Arlington High School Building Committee

Meeting Materials Package – 4/2/2024

Change Order (CO)

Date of Issuance: 06-March 2024 NO: **38**

AHS- ARLINGTON HIGH SCHOOL
SITE LIGHTING- BIKE PATH- OPTION 2

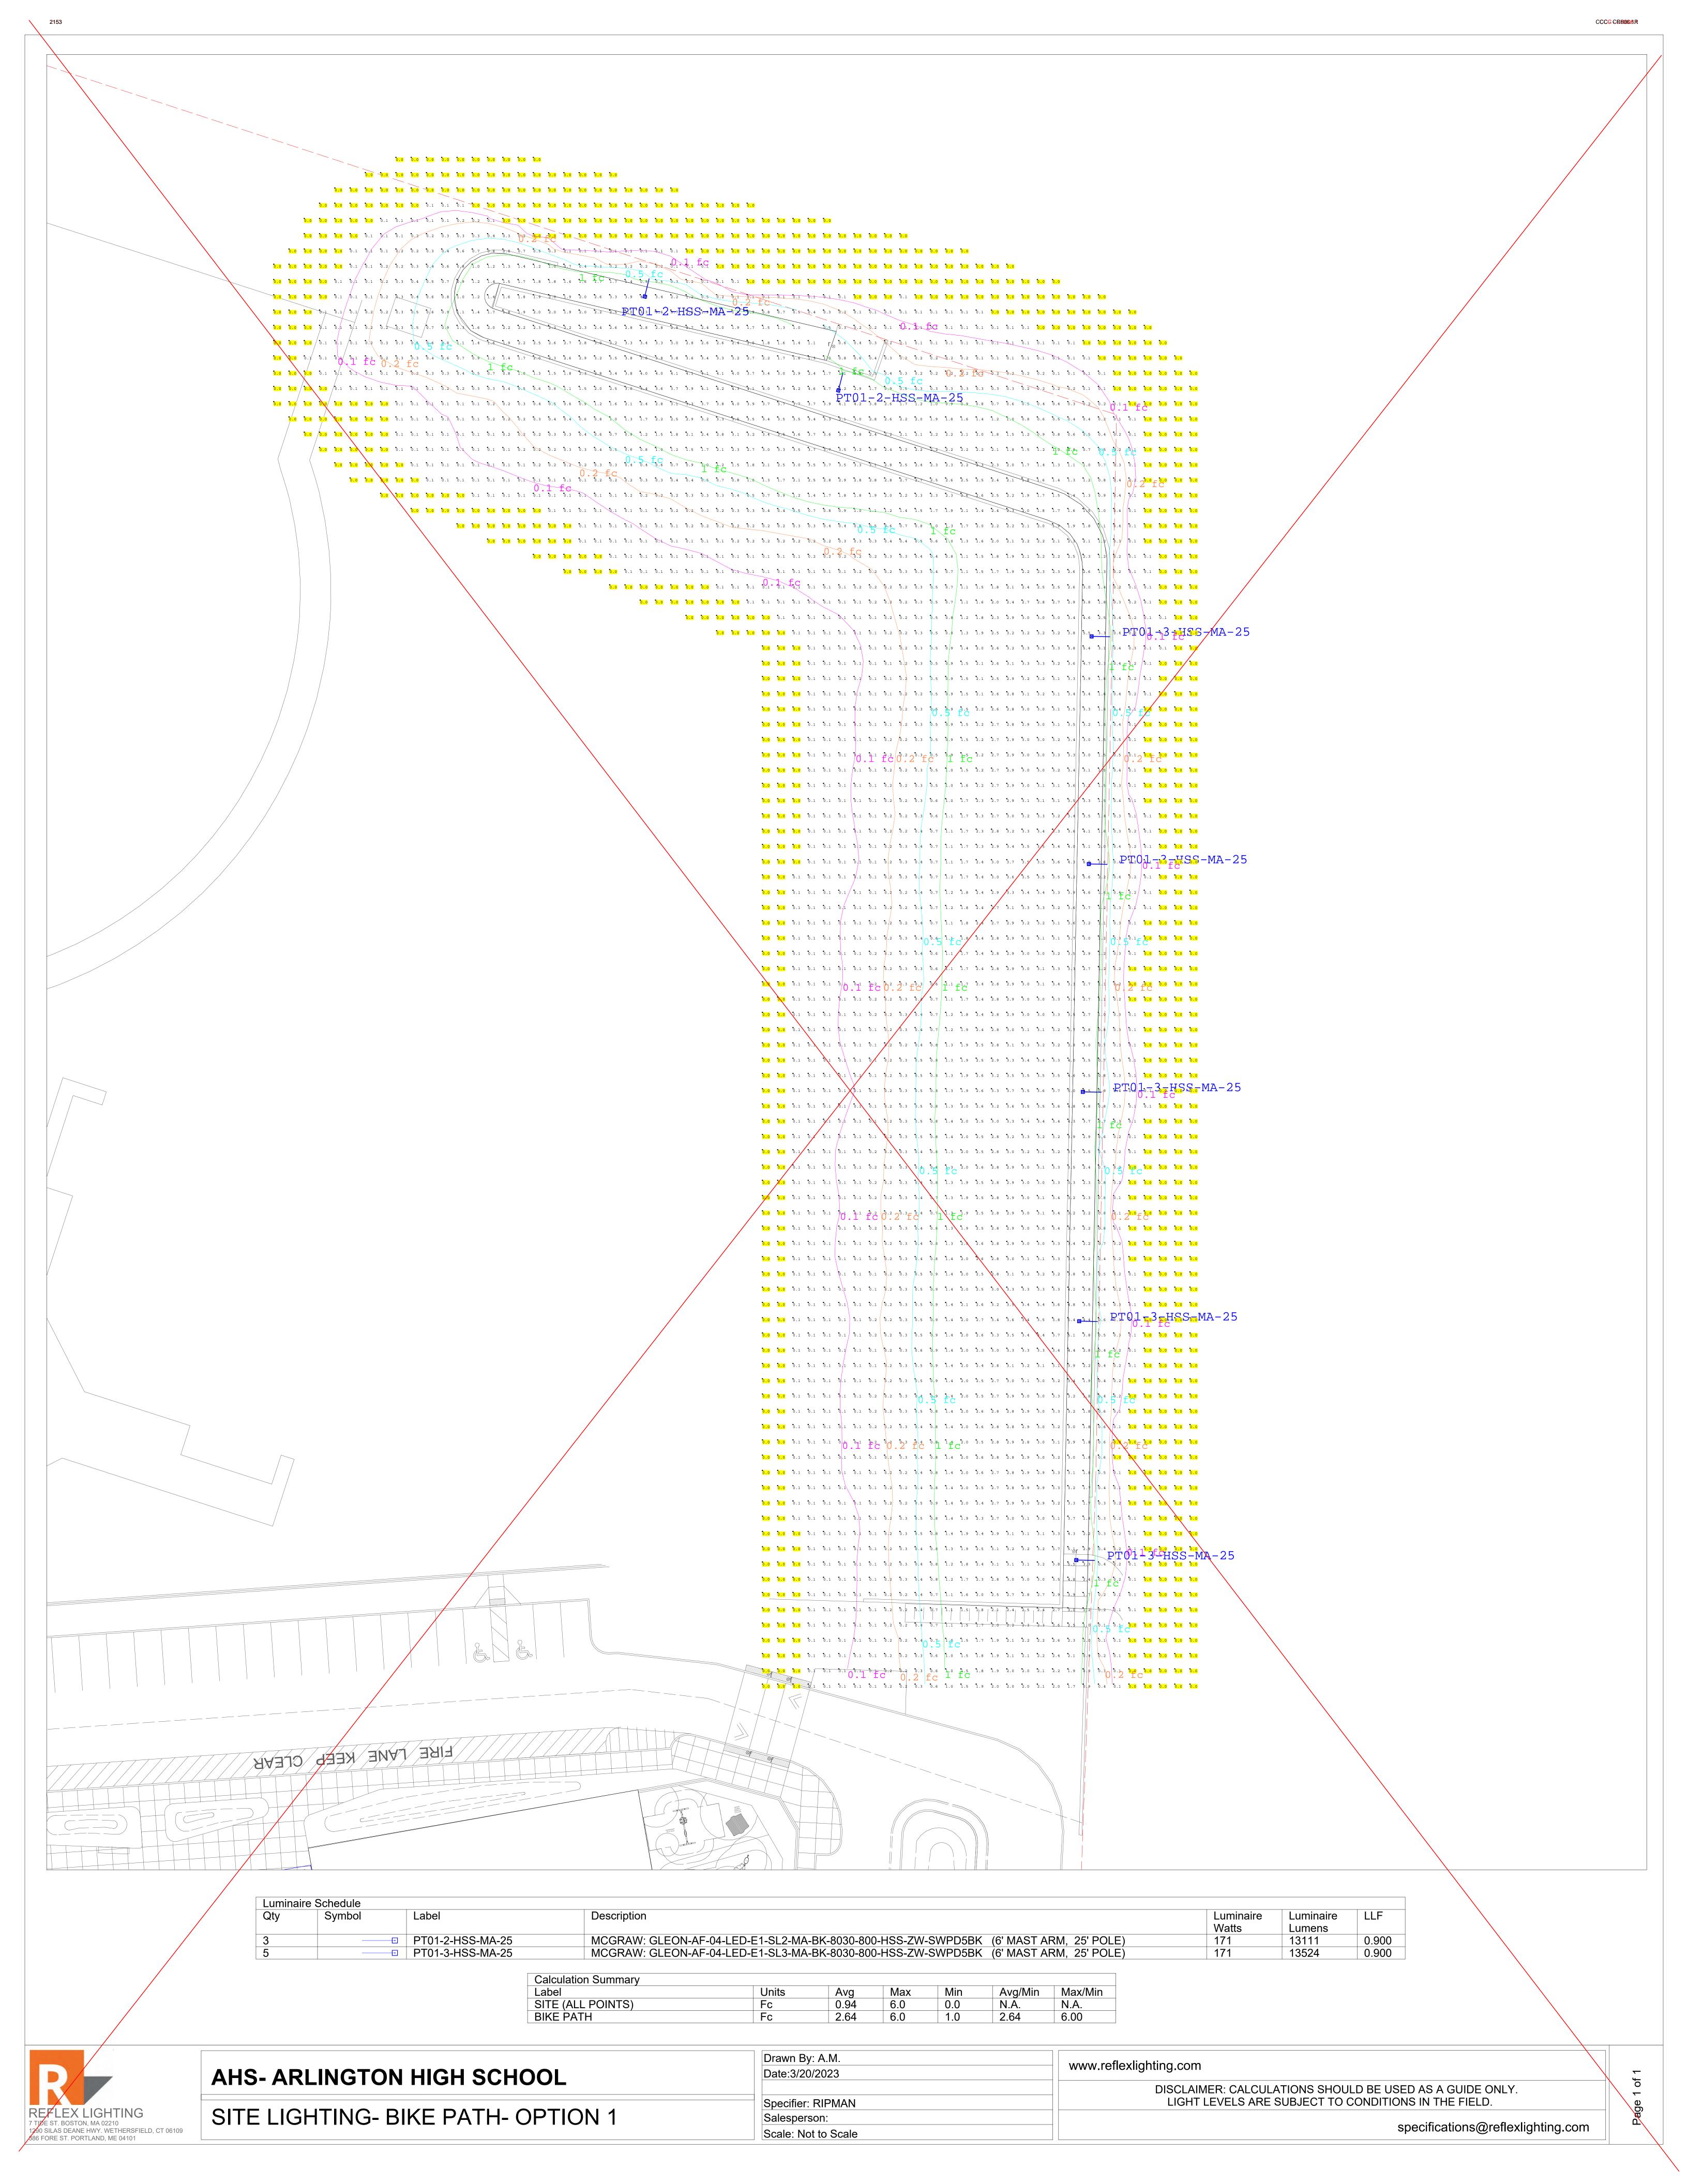
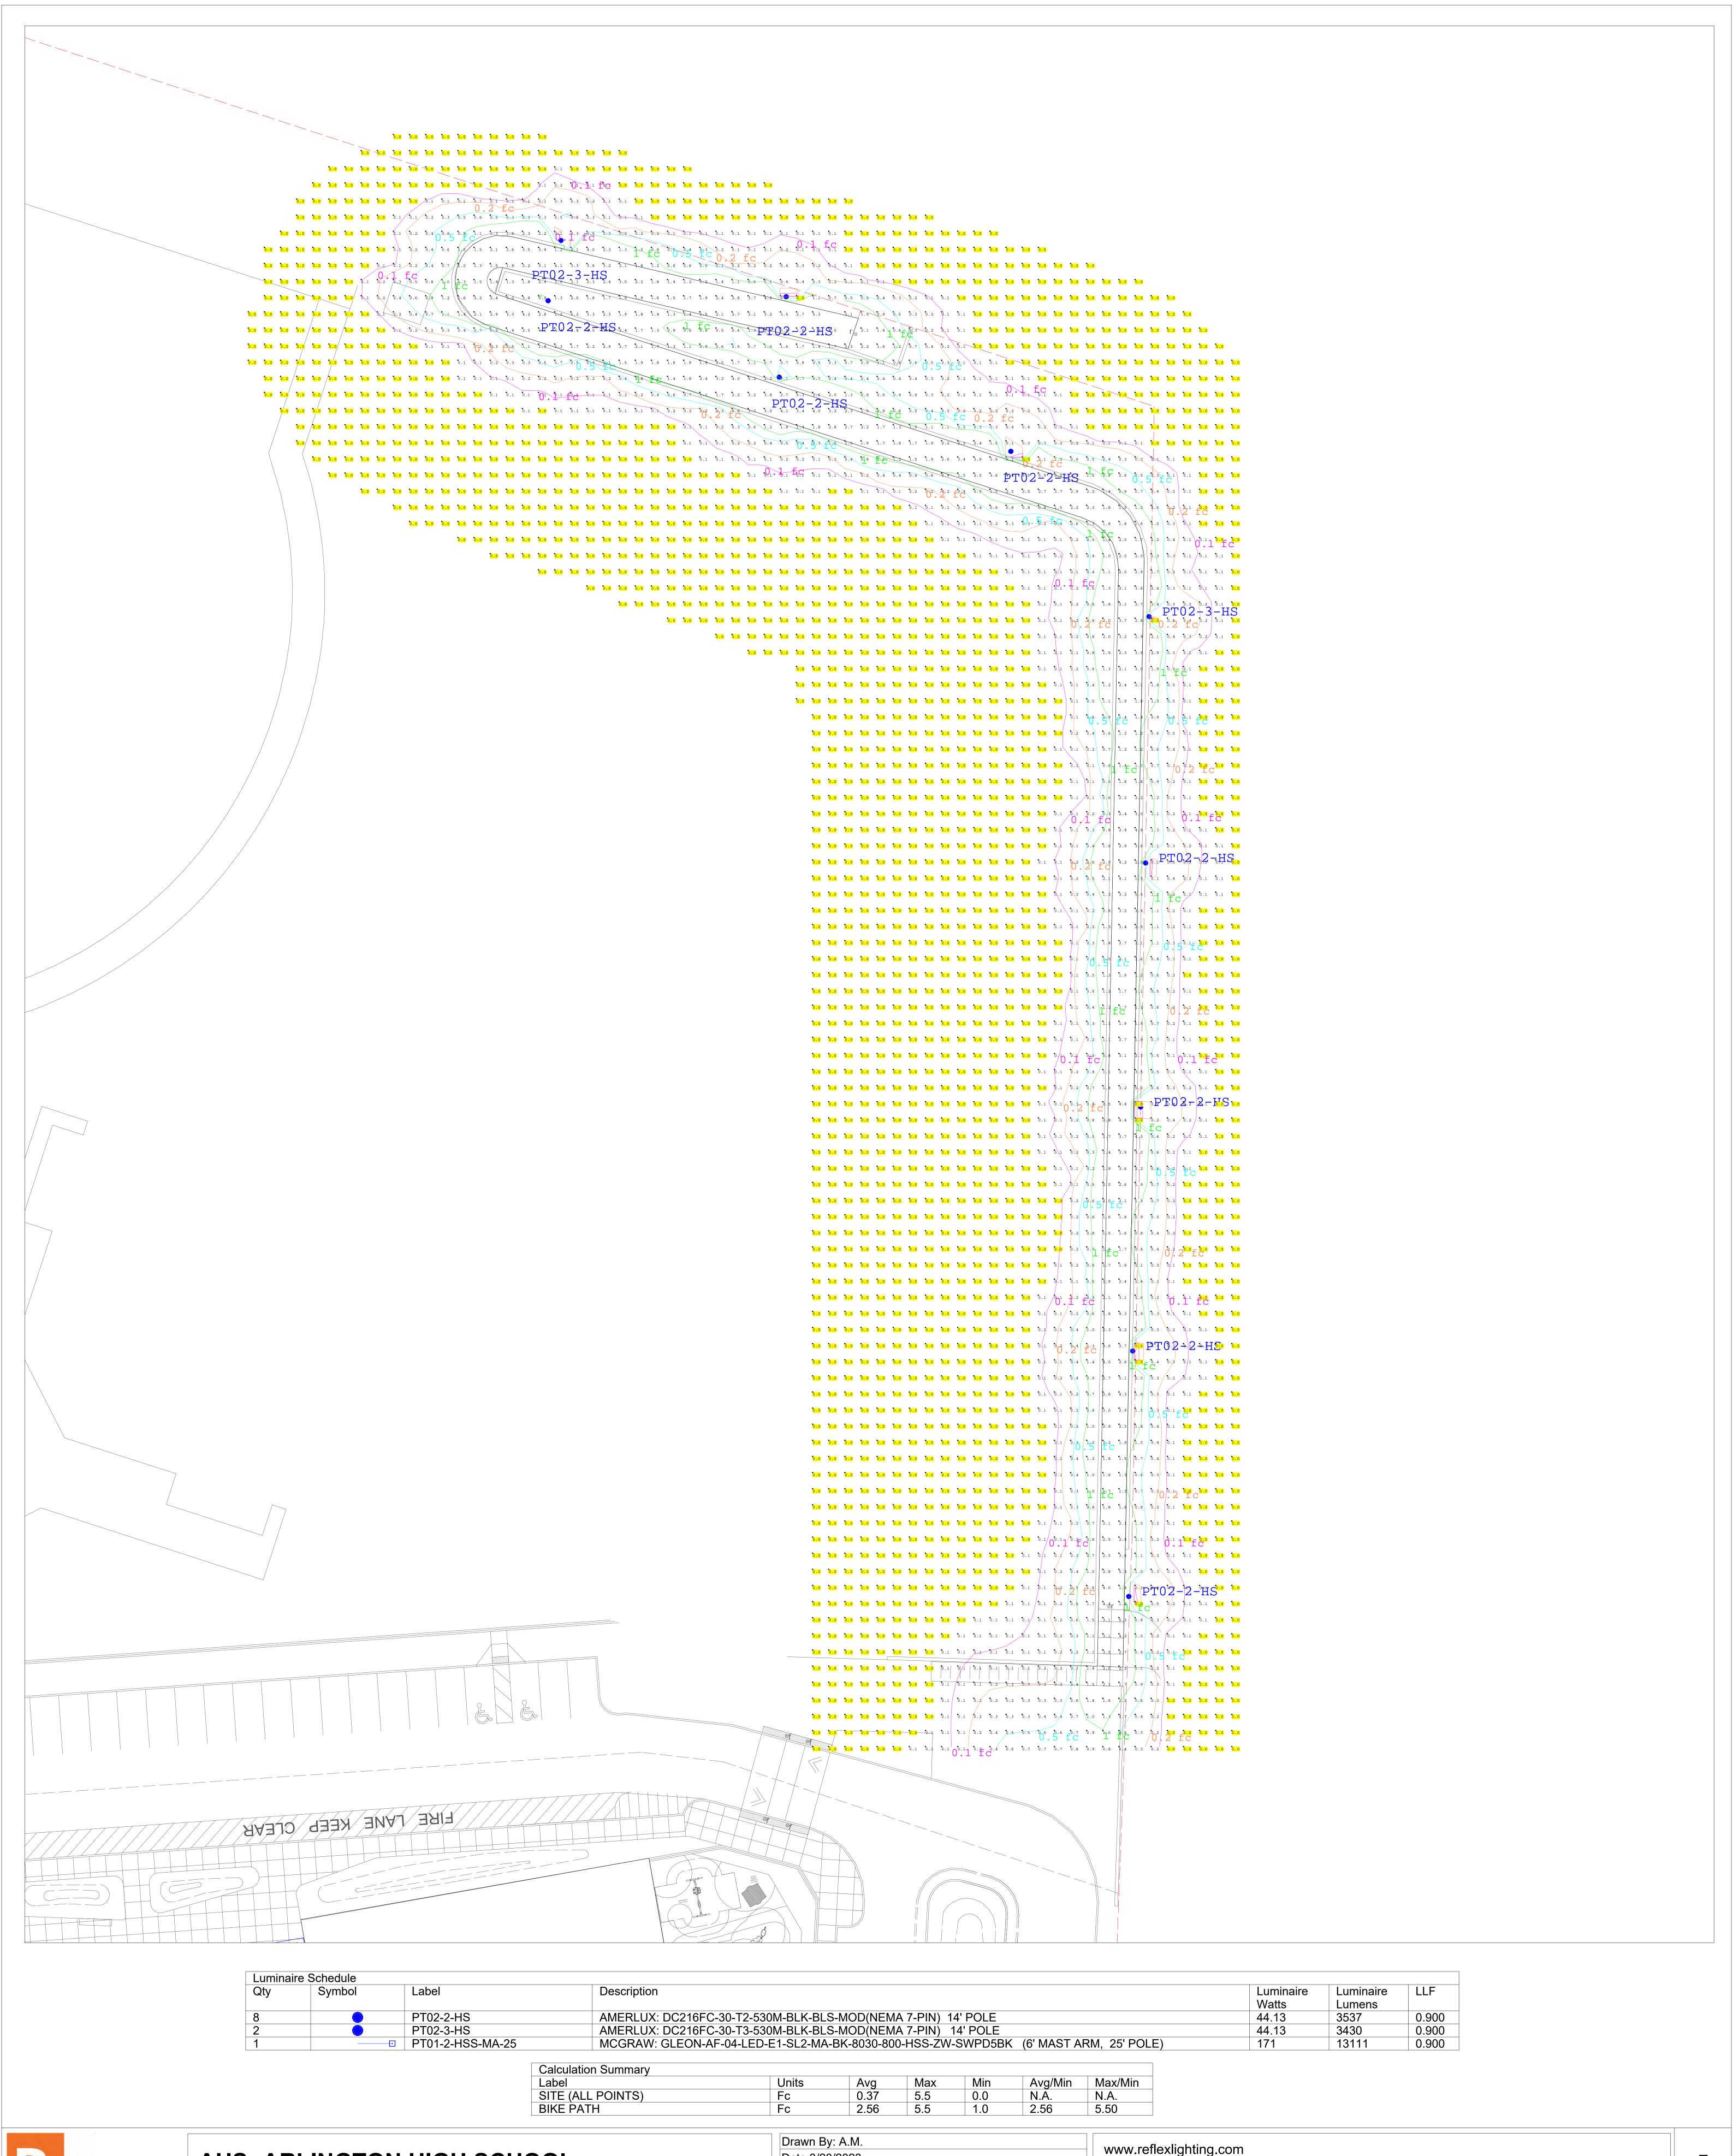
Please provide pricing for the attached bike path connector ramp lighting options 1 and 2

Option 1: Qty. (5) PT01-3 + Qty. (2) PT01-2 fixtures and associated bases

(28' tall fixtures)

Option 2: Qty. (8) PT02-2 + Qty. (2) PT02-3 fixtures and associated bases

(14' tall fixtures)

See attached photometric plans for reference on layout of above noted quantities

LIGHTING PLAN PART e: TWO ADDITIONAL EXIT SIGNS

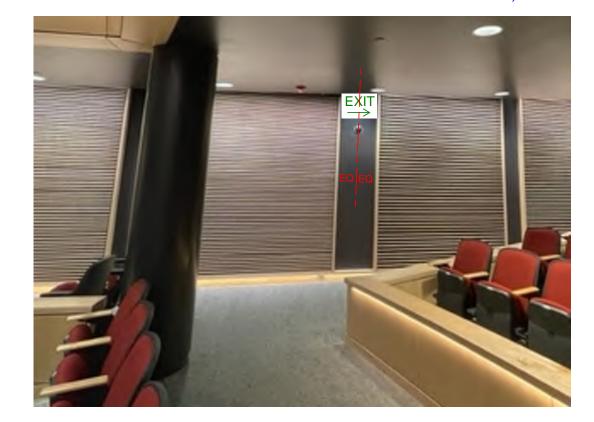
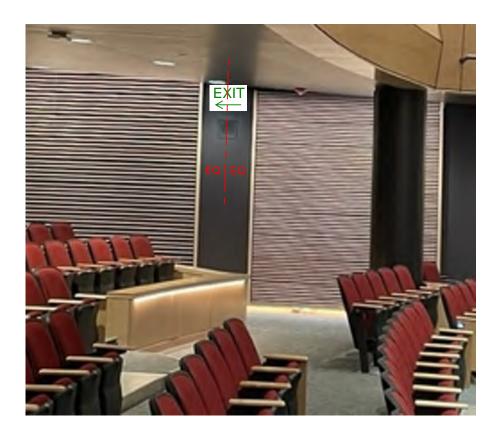
Provide two ceiling mounted exit signs at the Auditorium. Refer to attached sketch SKE-96. (per AHJ requirement)

Add lighted EXIT sign (ceiling mounted)

Add lighted EXIT sign (ceiling mounted)
